BusConnects Dublin Core Bus Corridor Projects

Corridor 6 – Lucan to City Centre

Emerging Preferred Route – Public Consultation Report 2018/2019

Section 1: N4, Ballyowen Road to M50 Bridge

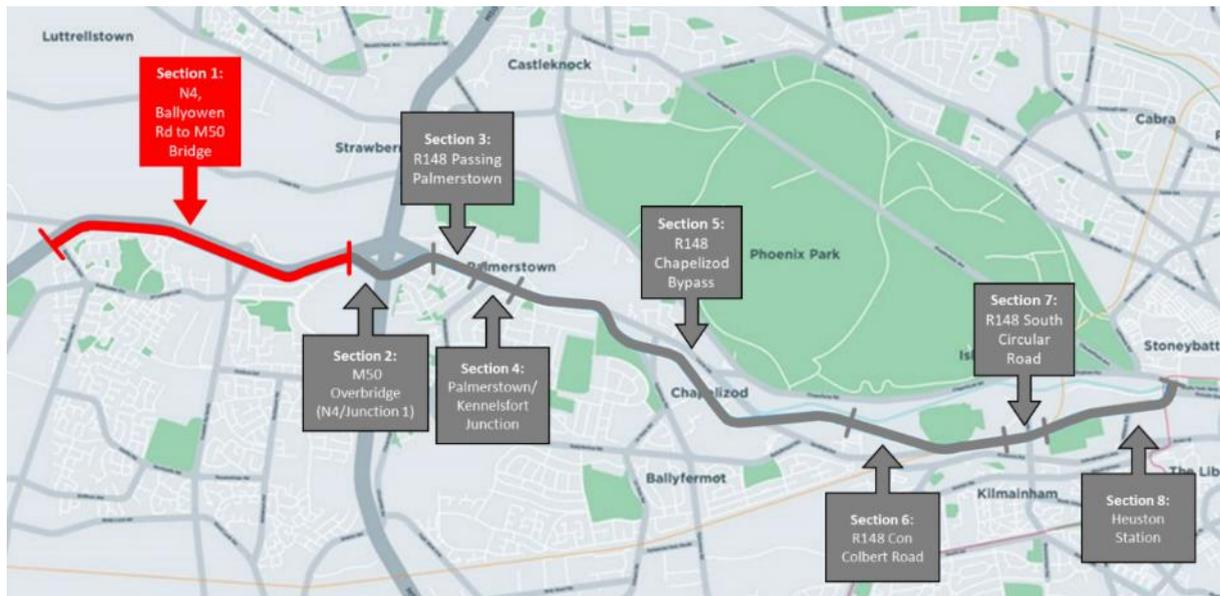
- It was felt that secure 'Park and Ride' facilities were required along the N4. Possible locations include Junction 5 (Leixlip-Celbridge) or at Junction 6 (Celbridge West – Leixlip West).
- It was suggested that ending the Core Bus Corridor at Junction 3 would be a missed opportunity and that it should extend west as far as Junction 5, in conjunction with a Park and Ride facility.
- Some submissions stated that two-way cycle lanes segregated by a physical buffer should be provided on both sides of the road throughout CBC 6.

- Submissions felt that the proposed bus stop on slip road outside Woodies was an inappropriate location and that Lucan traffic would come to a halt, with Woodville residents seeing no opportunity to exit their estate.
- Concerns were raised in relation to the cycle lane on the slip road from the Foxhunter to Woodies Bridge, with the proposed cycle lane being in the middle of three traffic lanes, which was felt to be unsafe for right turning cyclists who would then turn left from Lucan Road (Woodville Estate) onto Ballyowen Road.
- Residents questioned the need to alter the boundary wall at Woodville Estate as the cycle lane stops directly after the corner.

- It was felt there was space available here to provide segregated cycle facilities (inbound).

- Submissions noted that the map showed footpath to entrance of Hermitage Golf Course, which is sign posted as a private road.

- Some submissions highlighted the lack of continuity for cyclists at minor junctions to private properties and felt that cyclists should have priority over turning traffic in the same way as motorists.
- Submissions also felt there was a need to remove the kissing gates at the pedestrian / cyclist overbridge.

- Submissions raised concerns about the safety of shared surfaces, with cyclists travelling downhill from the N4 at speed on a shared path with pedestrians.

- A suggestion was made to make use of an island bus stop to avoid conflict between cyclists and buses, or at least a kneeling bus stop as seen on Map 7.

- Submissions highlighted that the Old Lucan Road carriageway was overly wide (8-12m), whereas the NCM sets maximum as 5.5 – 7m. Two solutions were offered:
 1. Narrow the carriageway to 5.5 – 6m to allow for wider footpaths and verge.
 2. Standardize the width to 8m and create 'Advisory Cycle Lane' as on page 58 of NCM.

Section 2: M50 Overbridge

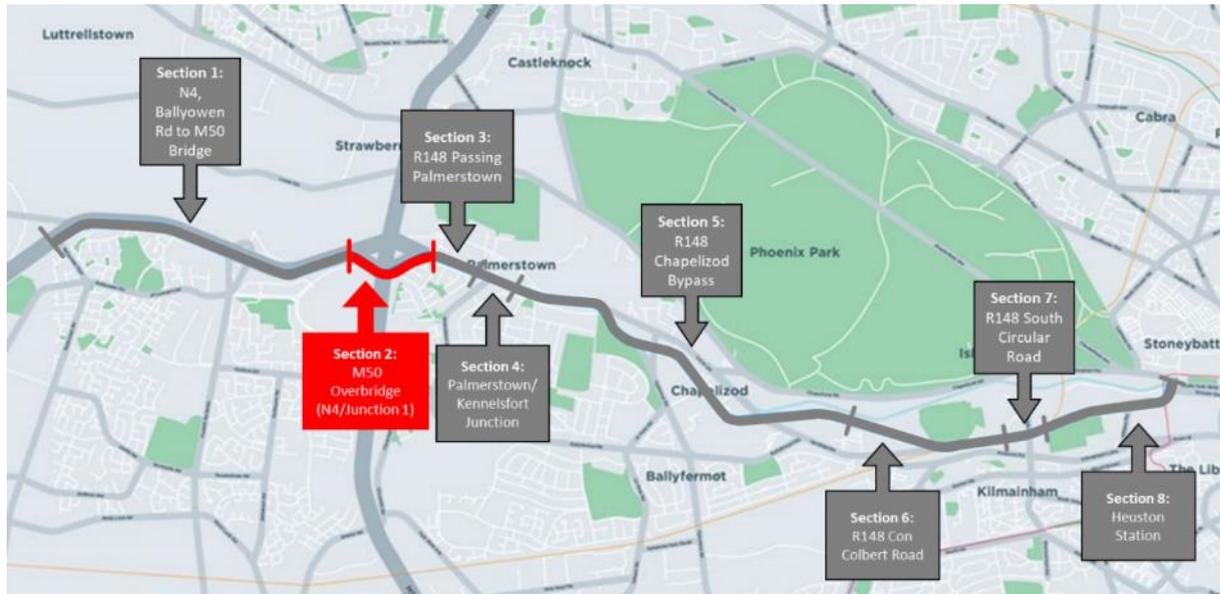
- Concerns were raised that the proposed reduction from 2 traffic lanes to 1 traffic lane on the M50 overpass to facilitate provision of a bus lane, in both the inbound and outbound direction, would have a serious impact on traffic congestion on the N4.

Section 3: R148/ Old Lucan Road to Palmerstown

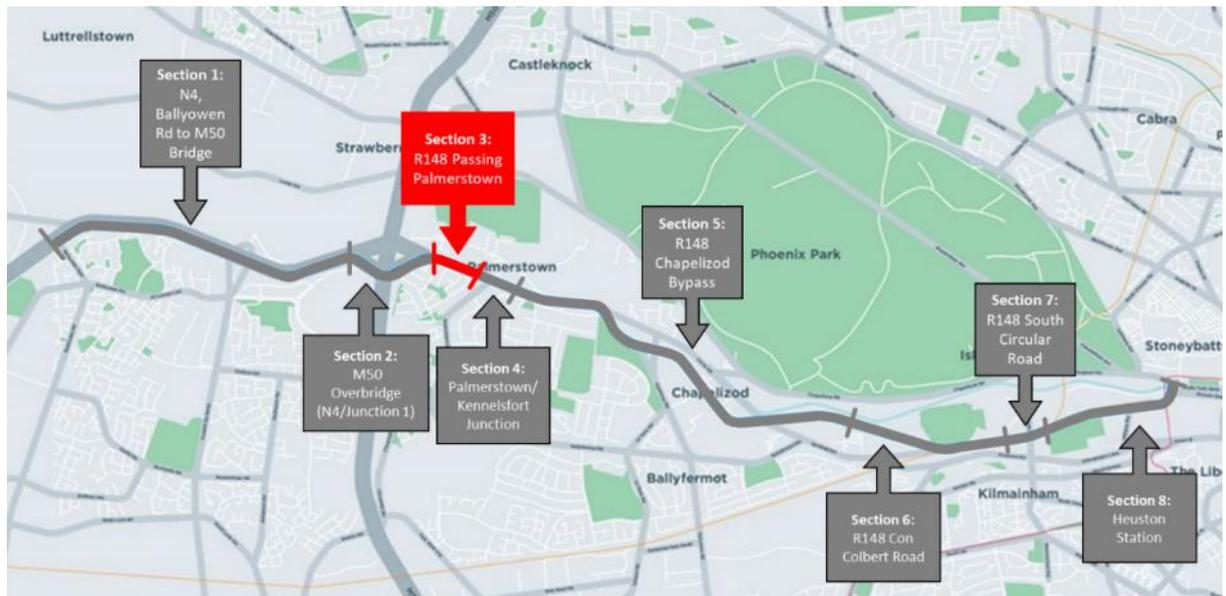
- It was felt that traffic calming measures were needed along Old Lucan Road to avoid high speeds and that there was too much on street parking.
- It was also noted that the carriageway is too wide, which encourages traffic to travel at higher speeds. The Dublin Cycling Campaign stated they had undertaken a speed survey and found average speeds to be 46km/h rather than the speed limit of 30 km/h. It was felt there was sufficient space to provide segregated cycle lanes which would help slow traffic down.
- It was suggested that on-street parking methods, as seen on Fitzwilliam Cycle Route, should be considered at Palmerstown.

Section 4: Kennelsfort Road Junction

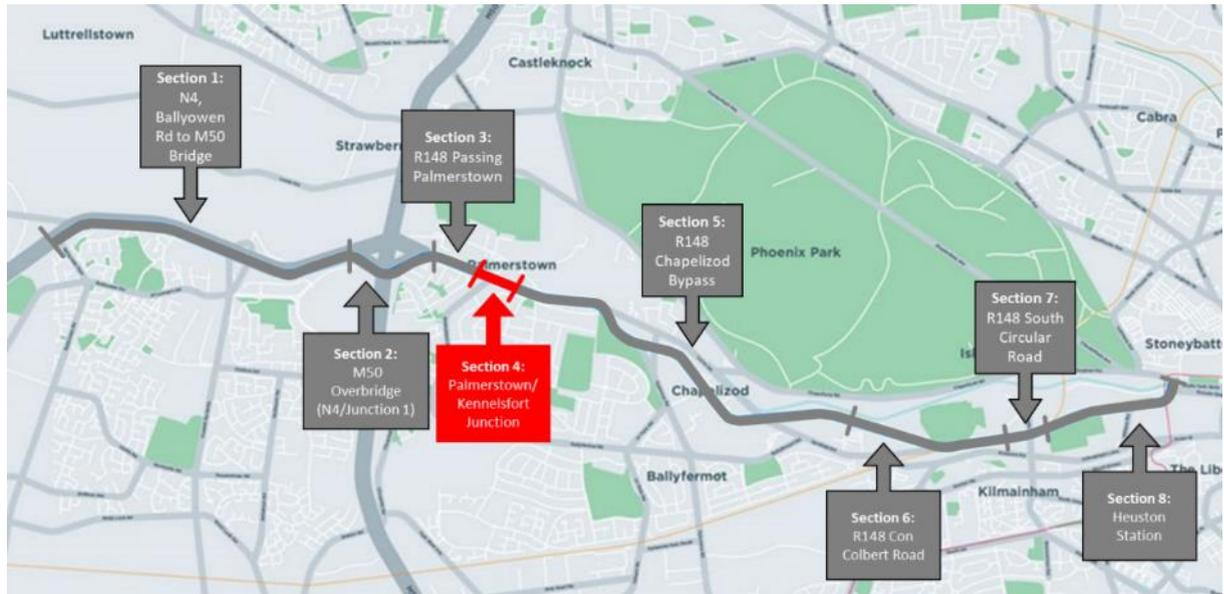
- A comment was made that extending the traffic island on western approach on Kennelsfort Road/ R148 junction would mitigate the number of drivers who U-turn here; the submission considered this a dangerous issue due to conflicts with traffic exiting the side road.

- The need for the proposed signalized pedestrian crossing at Kennelsfort Road was questioned given that there was a pedestrian overbridge currently available. There was a concern that this would add to existing congestion and impact traffic in both directions.
- A concern was raised about parking shown on the inside of the cycle lane on Kennelsfort Road Lower. It was felt that vehicles should not cross cycle lane in order to park and that the layout of on-street parking as seen on Fitzwilliam Cycle Route should be considered.
- Some submissions felt that the construction of interchange/underpass at the N4/Kennelsfort Road junction was a key piece of infrastructure which would reduce congestion, but also improve journey times to the City Centre from suburbs before Palmerstown.

Section 6: Con Colbert Road

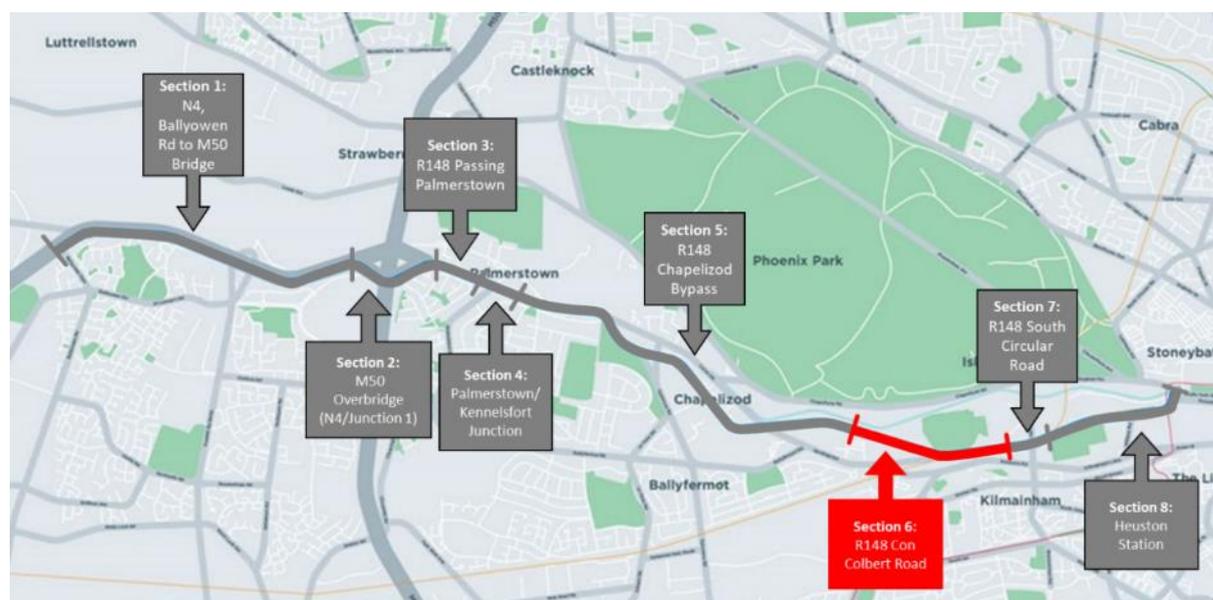
- It was noted that the plans showed the addition of cycle lanes on Memorial Road and it was felt that the right turn from Con Colbert Road onto Memorial Road must be designed for.

Section 7: South Circular Road Junction

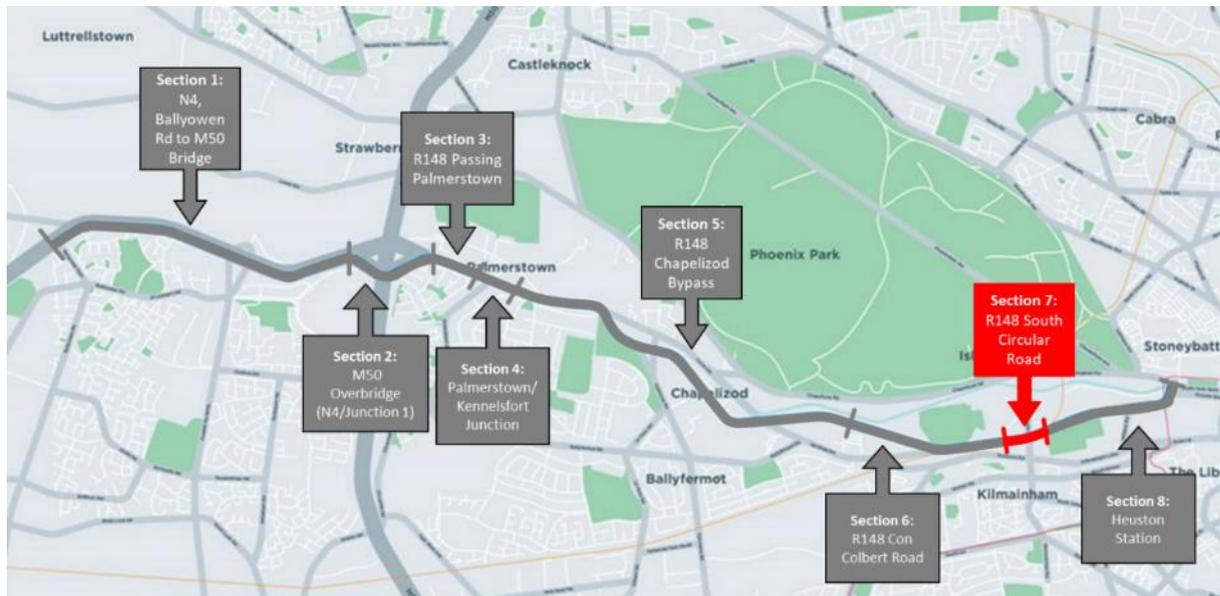
- Concern was raised about the left turn slip lane from St. John's Road West onto South Circular Road which it was felt should be removed, making a tighter angled left turn as per DMURS.
